ADDENDUM

ADDENDUM No.	2	GMCa JOB #:	202507 MBD
ISSUE DATE:	04.24.26	SBC #:	366/009-07-2025
PROJECT:	MTSU Beasley Hall Renovations – Phase I		323 Friendship Street Murfreesboro, TN 37132
OWNER:	Middle Tennessee State University		1301 East Main Street Murfreesboro, TN 37132
ARCHITECT:	Gilbert McLaughlin Casella architects		2305 Kline Ave, Suite 200 Nashville, TN 37211

1 DEMOLITION PLAN: LEVEL 1
SCALE: 1/8" = 1'-0"

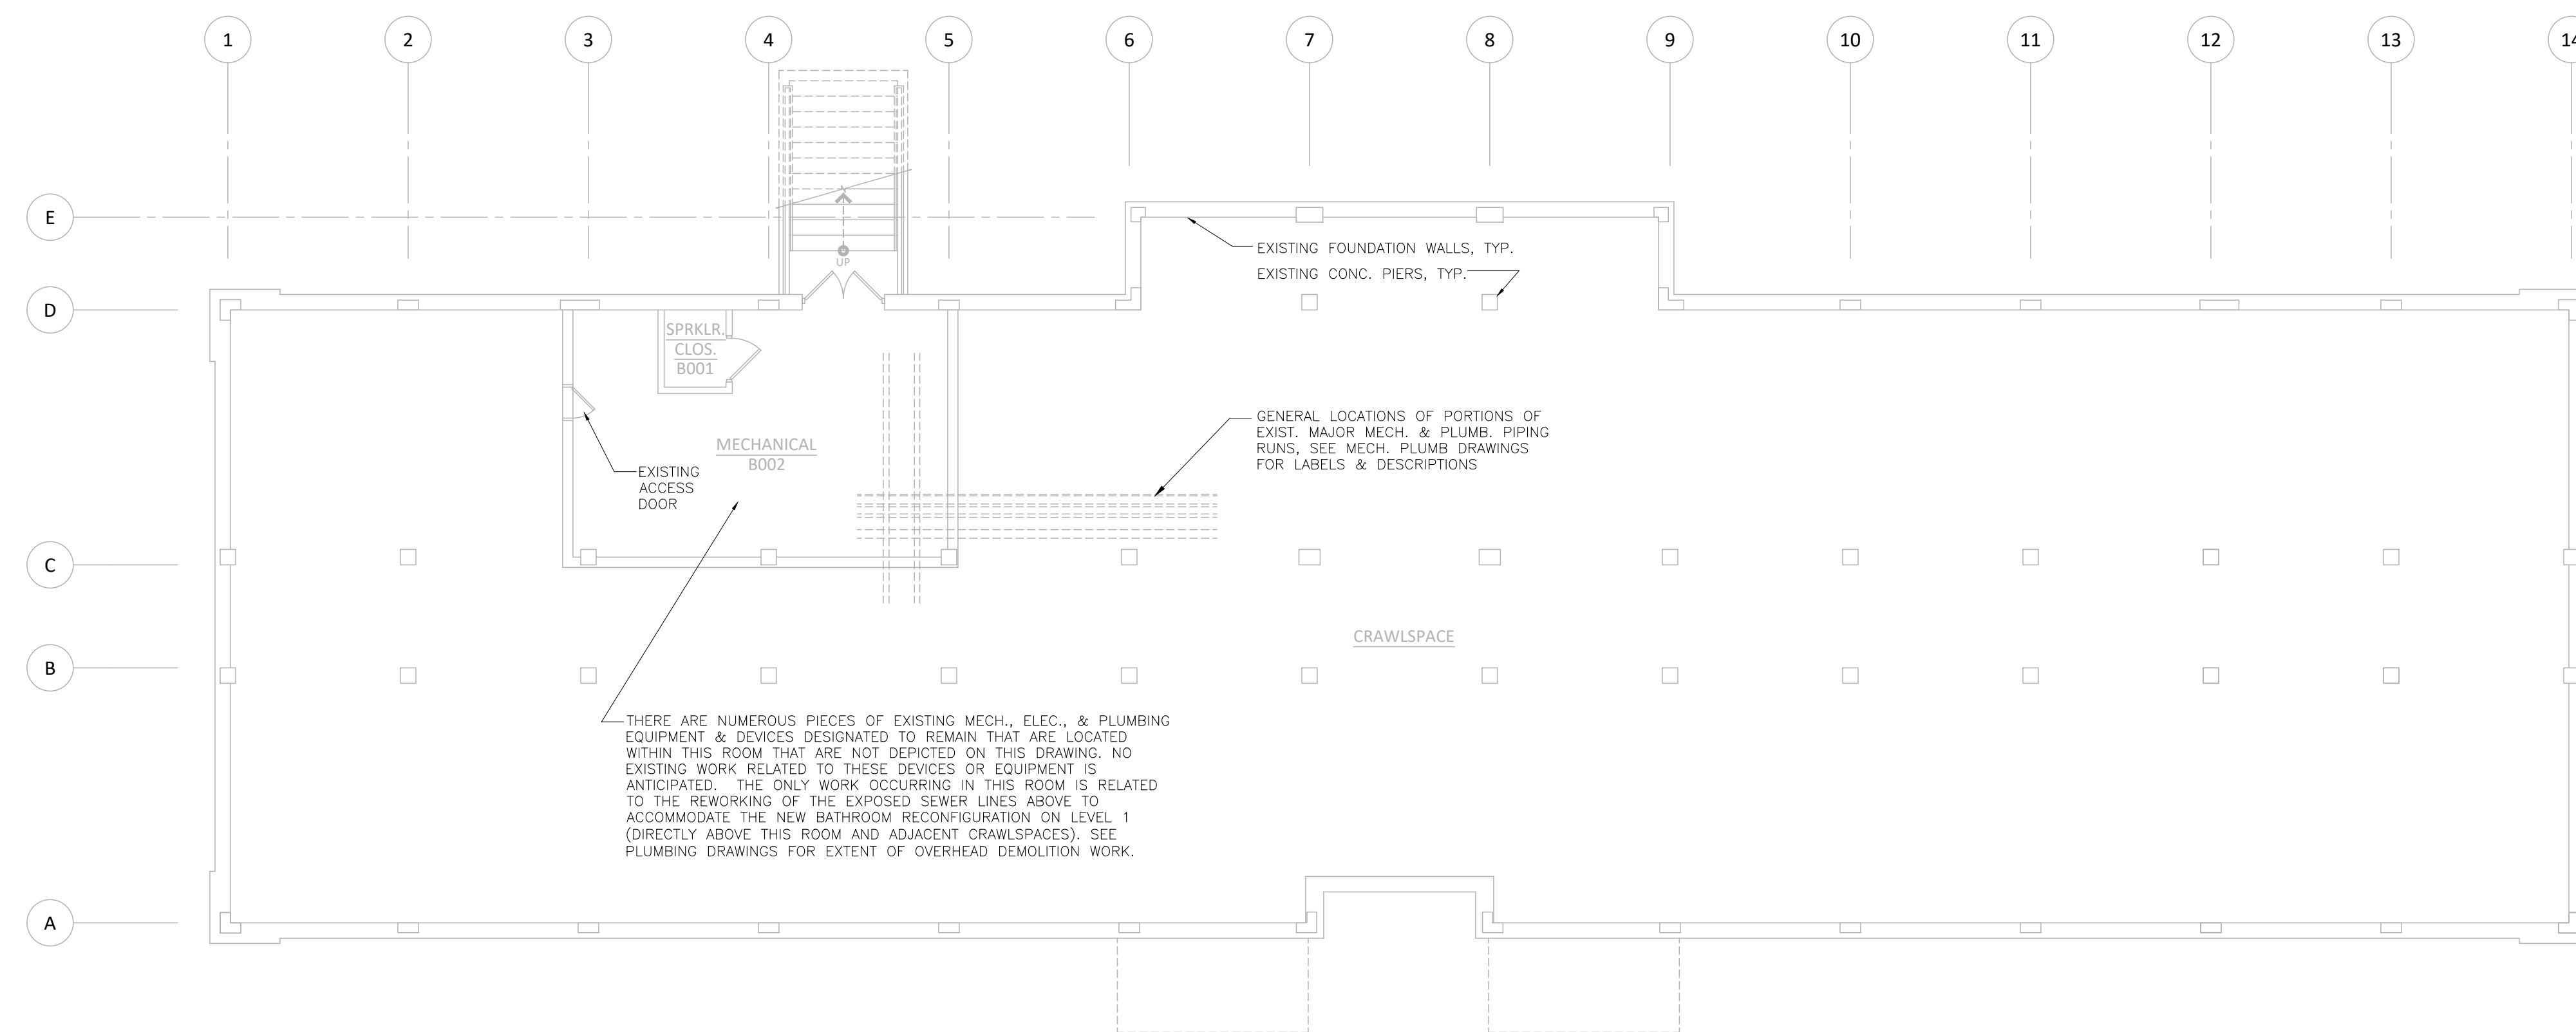
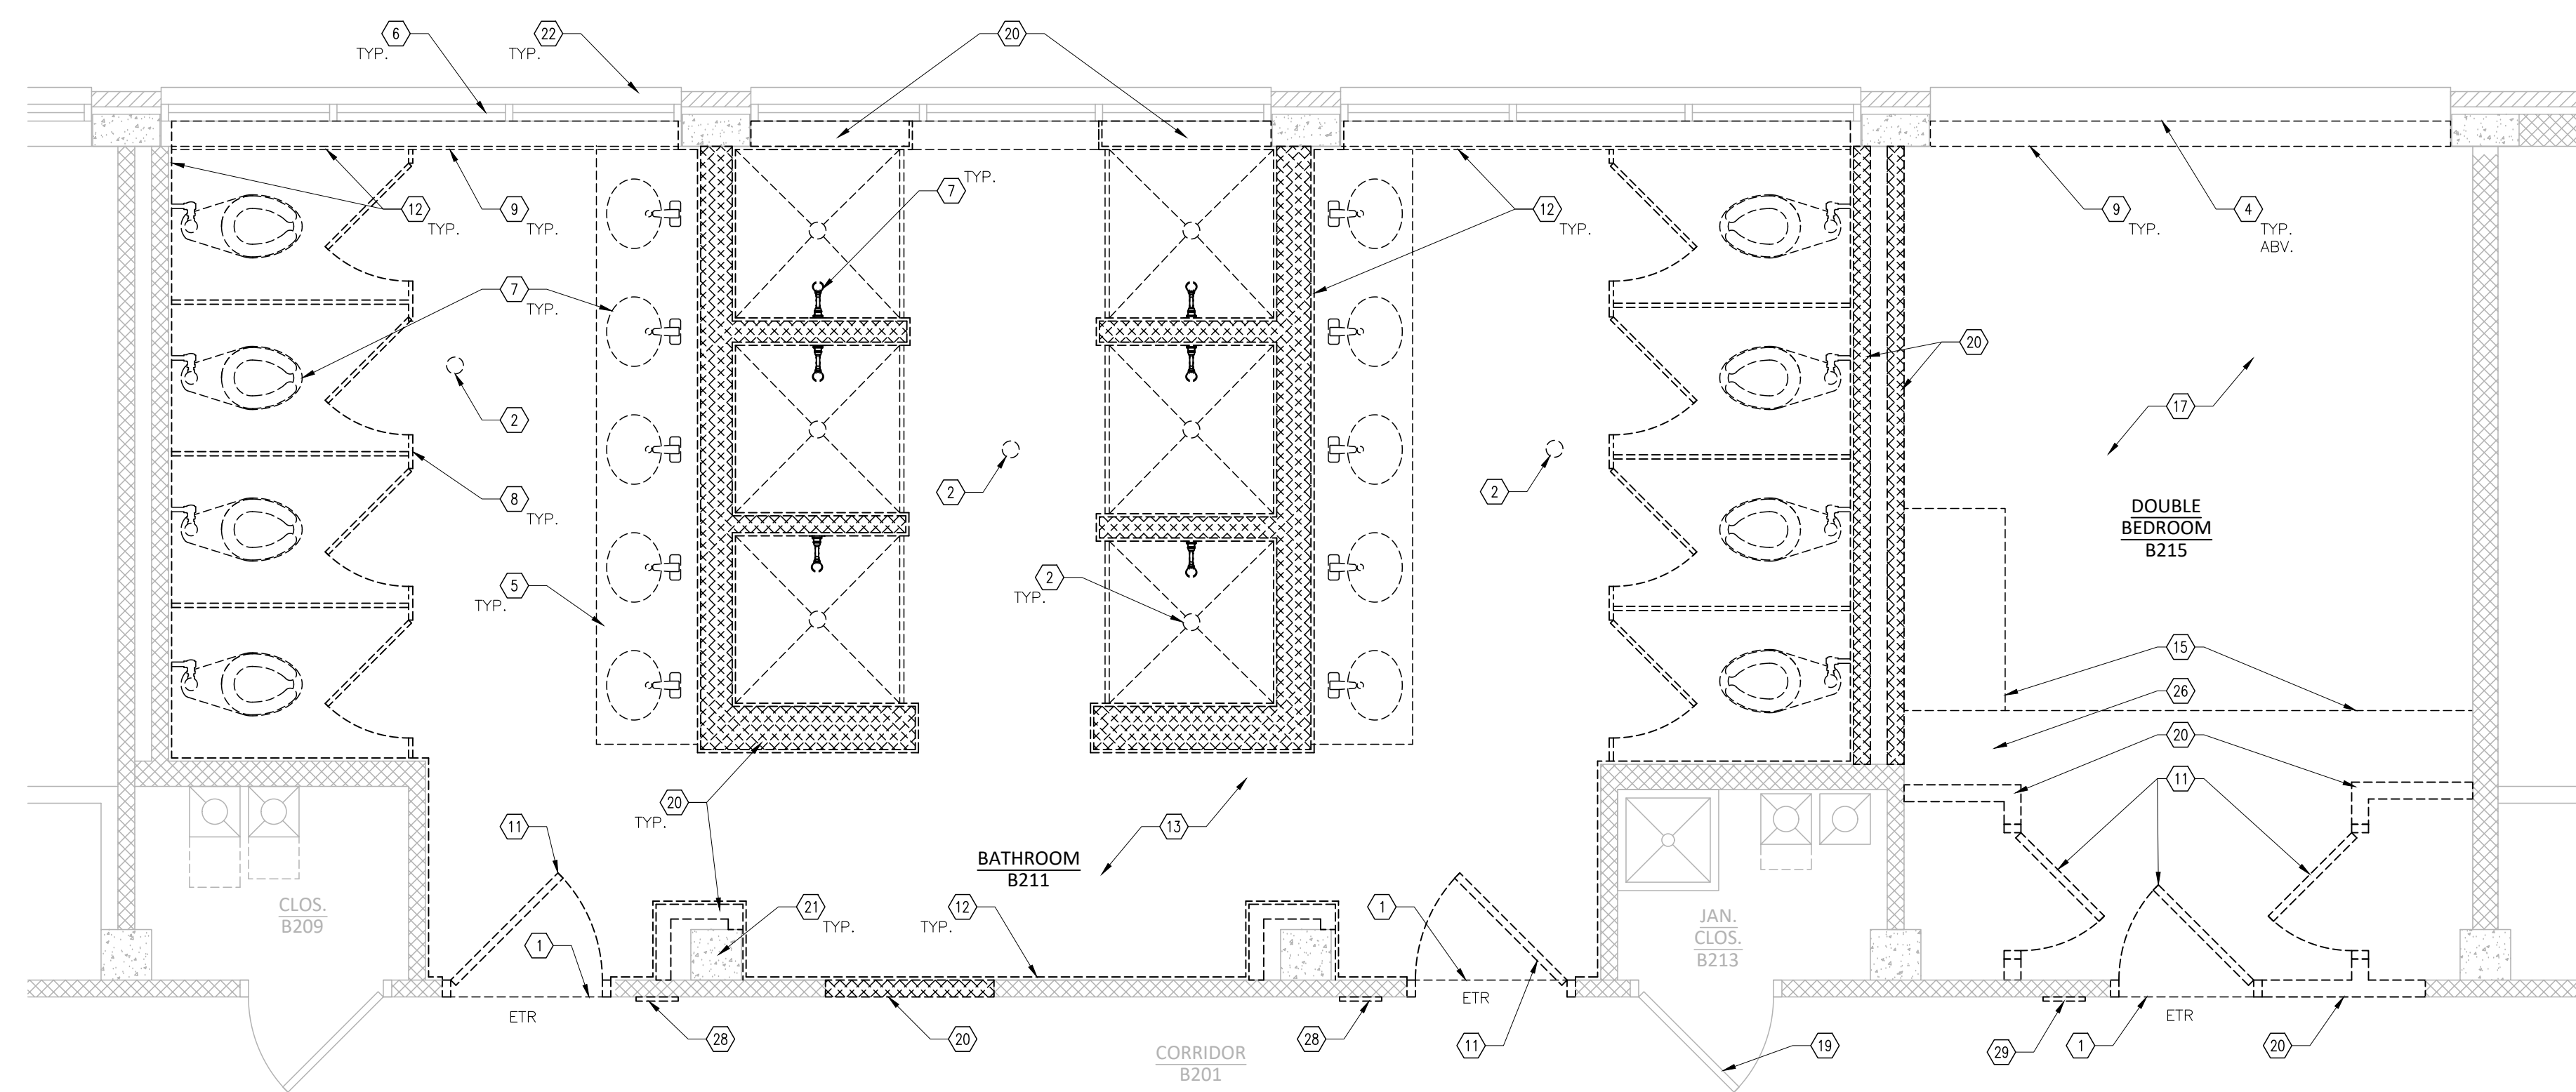
- a. On plan #1 - Level 1 Demolition, changed label for Corridor-B103 to be Corridor-B113B (B103 was already used at Bathroom-B103)
- 5. A1.1 – FLOOR PLANS: BASEMENT & LEVEL 1

1 ENLARGED DEMOLITION PLAN: LEVEL 1
SCALE: 3/8" = 1'-0"

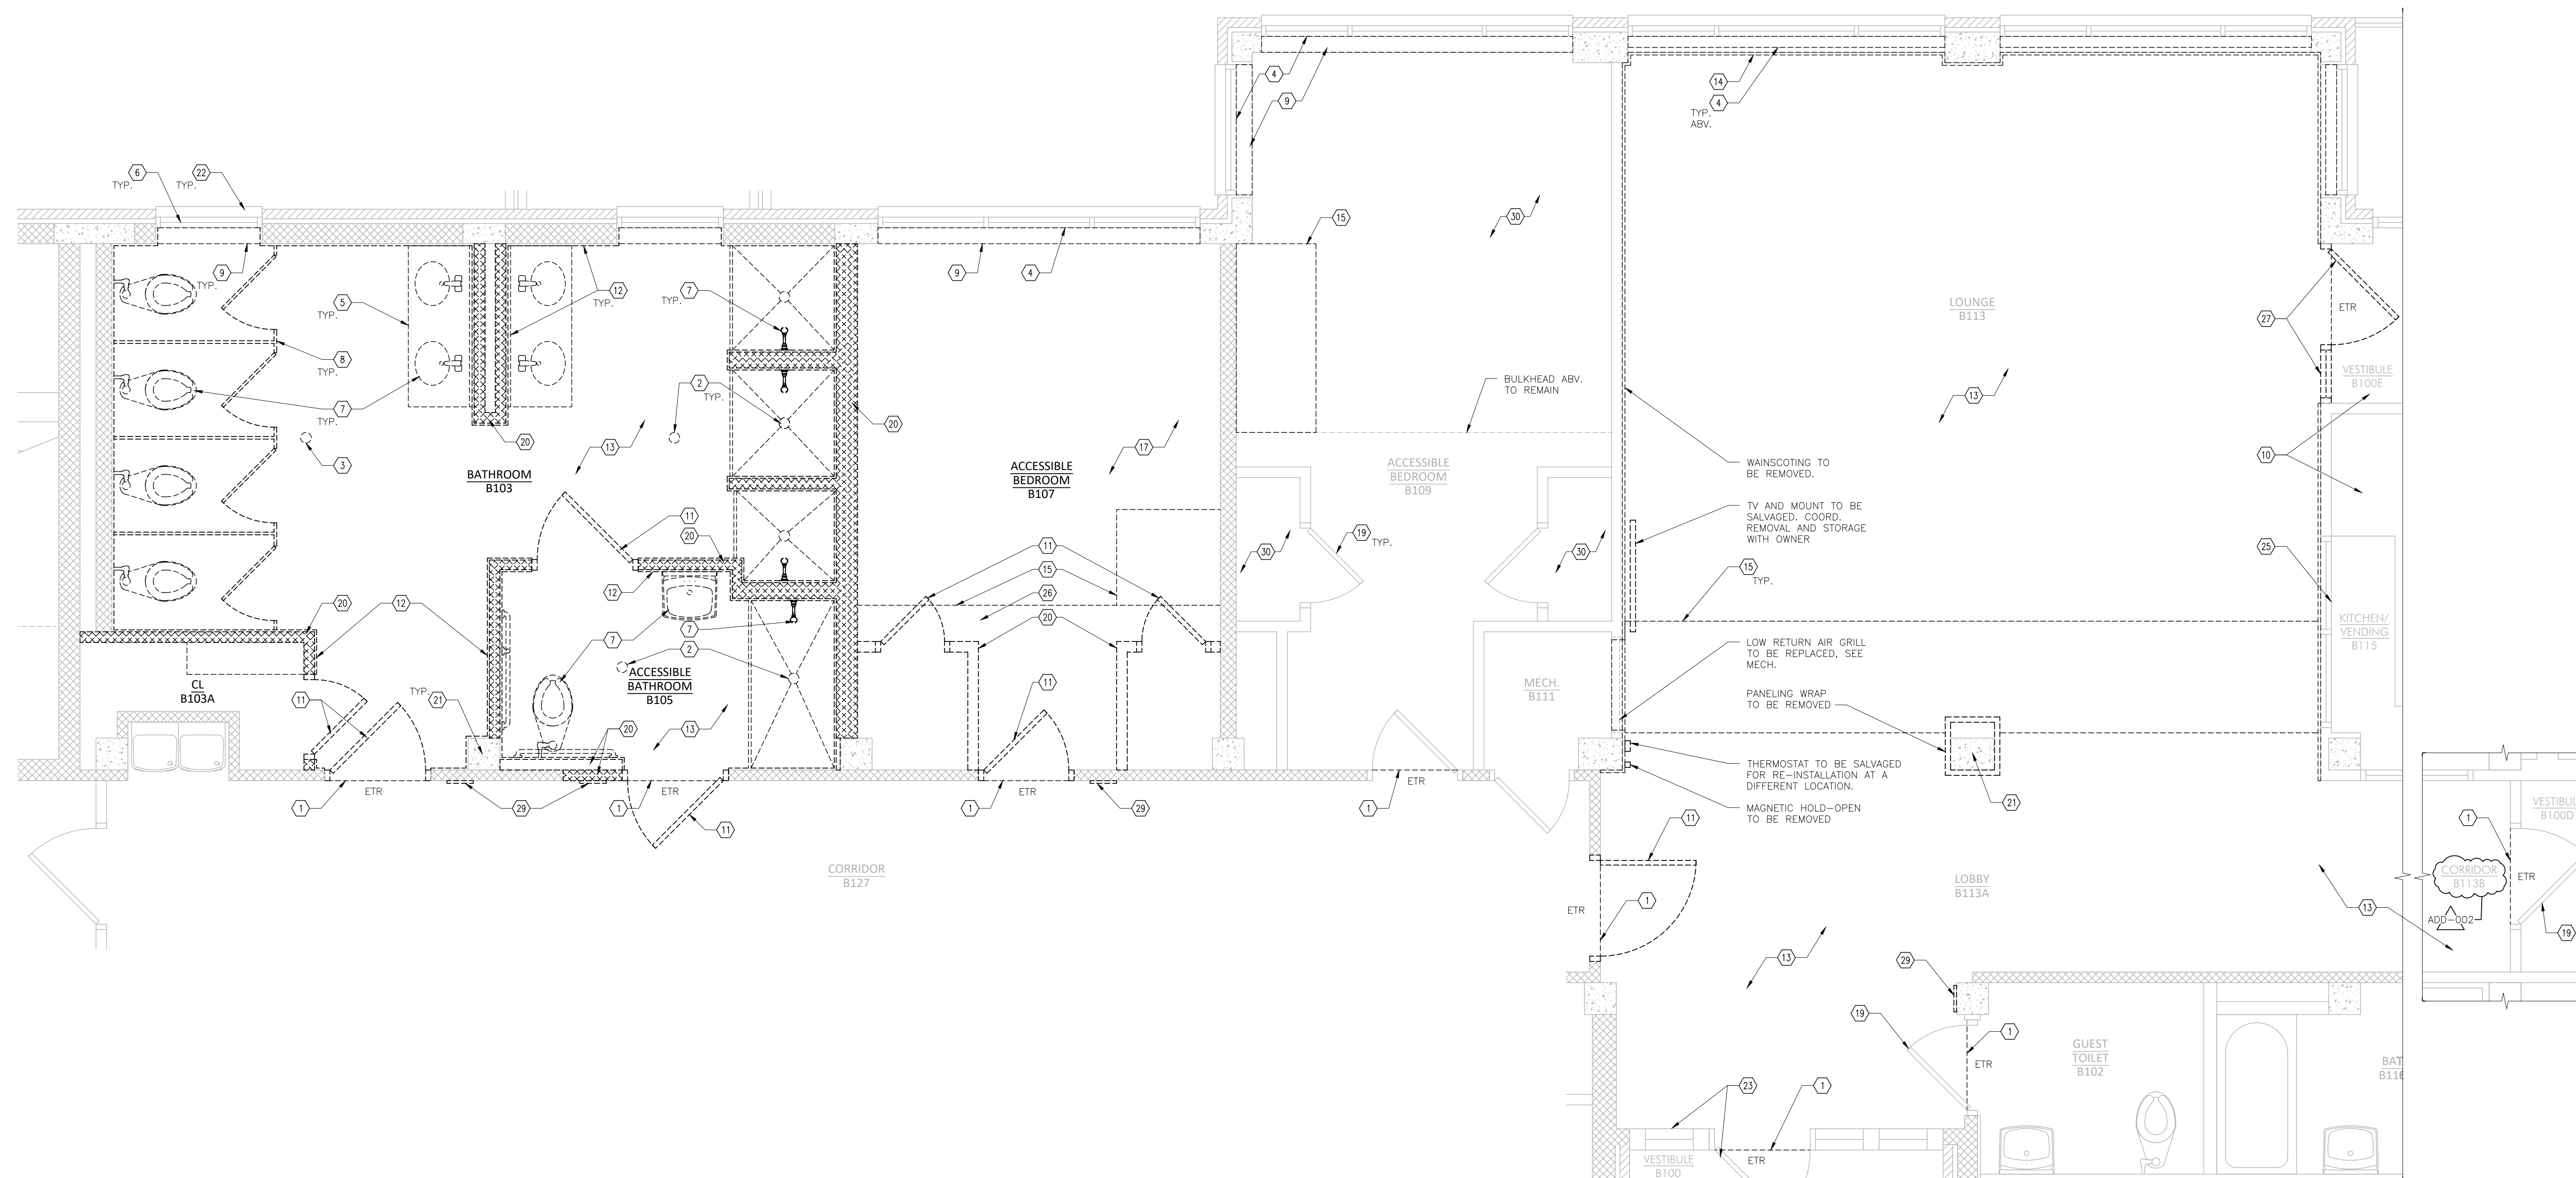
- a. On plan #1 - Level 1 Demolition, changed label for Corridor-B103 to be Corridor-B113B (B103 was already used at Bathroom-B103)
- 6. A6.1 – ENLARGED PLANS

1 LIFE SAFETY DIAGRAM - LEVEL 1
SCALE: 1/8" = 1'-0"

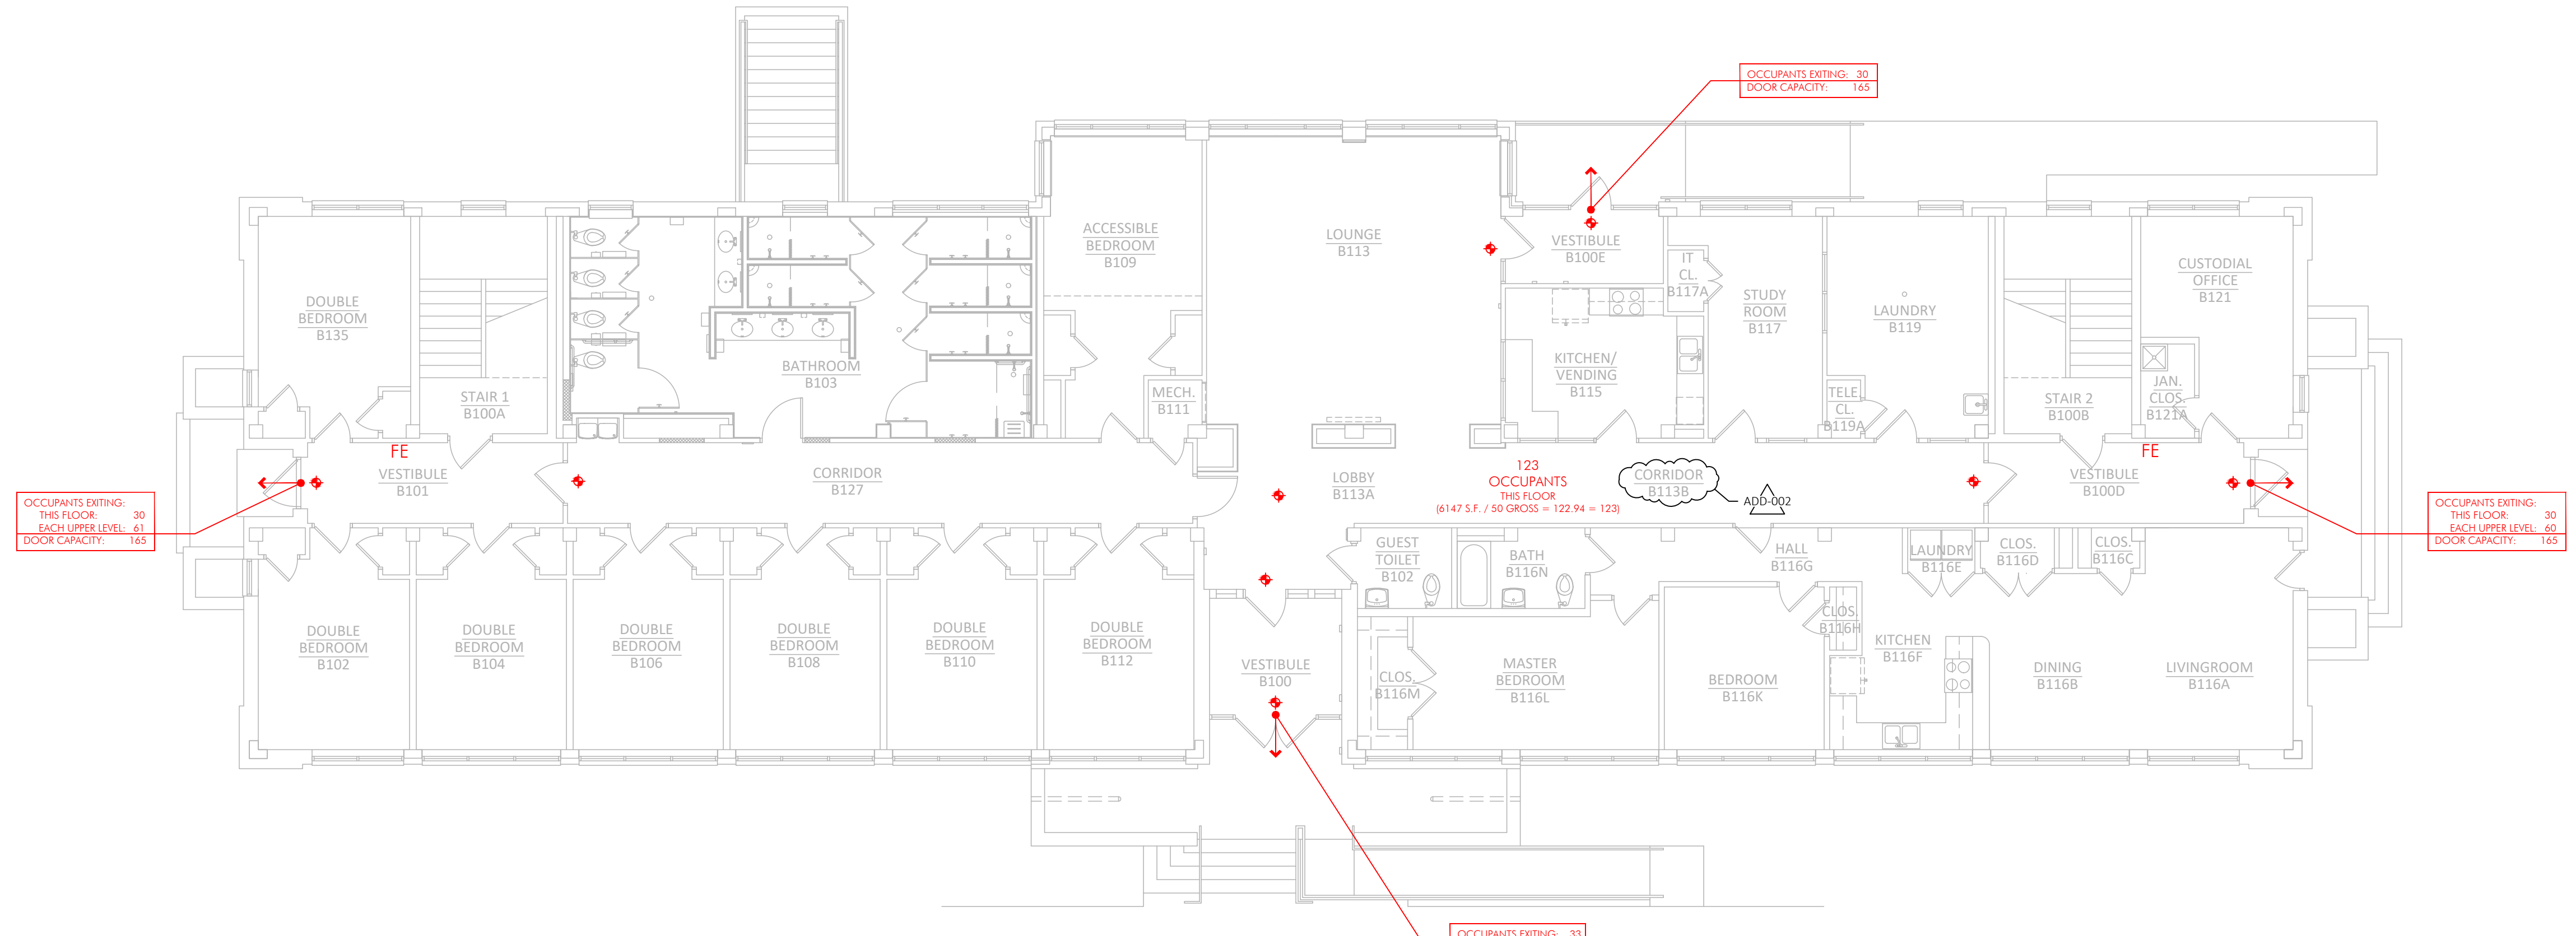
- 1. INDEX SHEET
 - a. Index tracking information was added to revised sheets.
- 2. A0.1 – LIFE SAFETY DIAGRAMS
 - a. On plan #1 - Level 1, changed label for Corridor-B103 to be Corridor-B113B (B103 was already used at Bathroom-B103)
- 3. AD1.1 – DEMOLITION FLOOR PLANS: BASEMENT & LEVEL 1
- 4. AD6.1 – ENLARGED DEMOLITION PLANS
